Department of Planning & Infrastructure
GPO Box 39
Sydney NSW 2001

8 November 2013

Re: S75W Application – Allengrove Crescent (MP10_0037)
Additional Information/Amended Plans

Figure 1: Concept Plan for the roof light elements

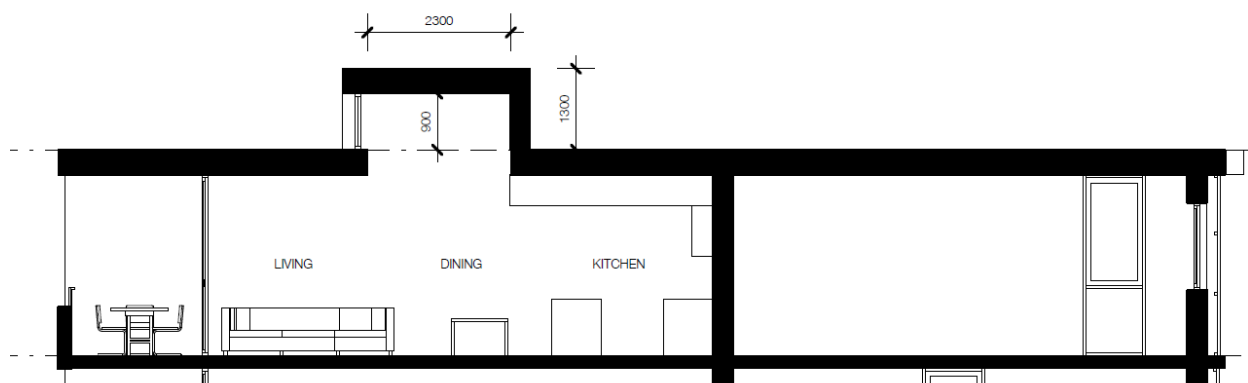
In response to the concerns raised by the City of Ryde Council and the Council's Urban Design Review Panel, the design of the proposed development has been amended to delete the proposed lightwells.

To offset the reduction in cross ventilation caused by the deletion of the lightwells, "pop up" roof window elements have been added to 13 apartments. The proposed development will still achieve the minimum requirement of 60% of units achieving cross ventilation through the use of the proposed roof lights

The roof lights are located on buildings B, C, D and E and have been sited over living and dining areas of the respective units to provide maximum amenity. The roof lights are setback from the roof edge to ensure that they have no overshadowing impacts on surrounding properties and to minimise visibility and any potential concerns in relation to visual impact.

It is noted that the roof light elements may be visible on Building E from the north-west across Lane Cove Road, however given the setback of the roof lights from the roof edge, it is considered that these elements are unlikely to have any significant visual impact. The perimeter roof edge will still read as the predominant element and the roof lights will be ancillary secondary elements.

Figure 2: Setbacks to western half of Building D

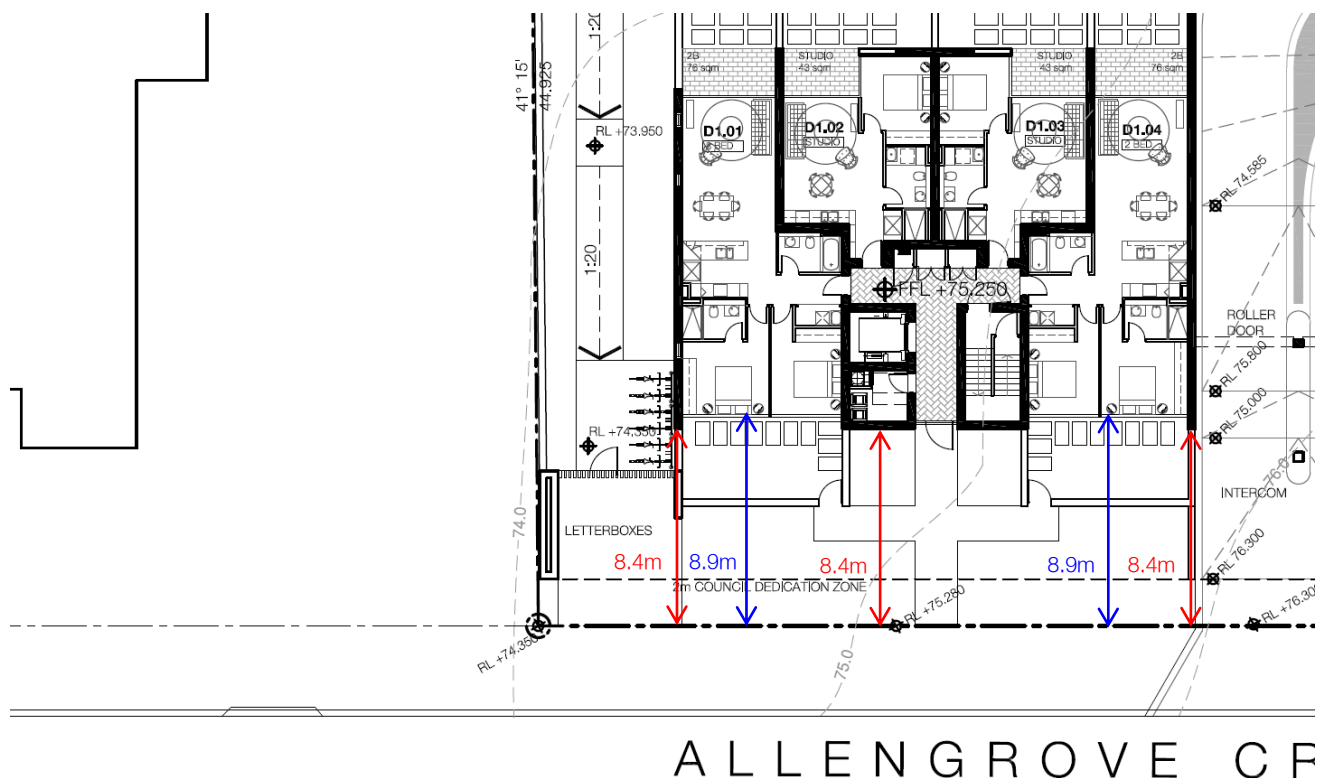
Further to the amended plans, we note that at the abovementioned meeting, you raised concerns in relation to the proposed amendment to the front building envelope setback to Allengrove Crescent.

The S75W application as submitted to the Department has sought to amend the envelope by 500mm to a minimum setback of 8.4m to enable the lift and stair core to Building D and blade walls to project by 500mm. Figures 2 and 3 below provide further details of the proposed front setbacks to Allengrove Crescent. A copy of the coloured perspective of the Allengrove Crescent elevation is also provided for your reference at Attachment 1.

We are of the opinion that the minor variation in the front setback will not result in any significant detrimental impacts on the Allengrove Crescent streetscape. The majority of the façade of the building complies with the 8.9m setback (as shown in Figures 2 and 3), with only the stair cores and blade wall elements projecting forwards of the 8.9m envelope. In fact, Dwellings 1.07 and 1.08 at the eastern end exceed the required 8.9m setback with setbacks of 9.9m to the glazing line.

The proposed setbacks are consistent with the front setback of the neighbouring buildings on either side of the site. In this respect, we are of the opinion that the minor amendment to the Concept Approval to enable the 500mm projection of the lift/stair core and blade walls forward of the envelope is not unreasonable and will not have any detrimental impacts on the streetscape or neighbouring properties.
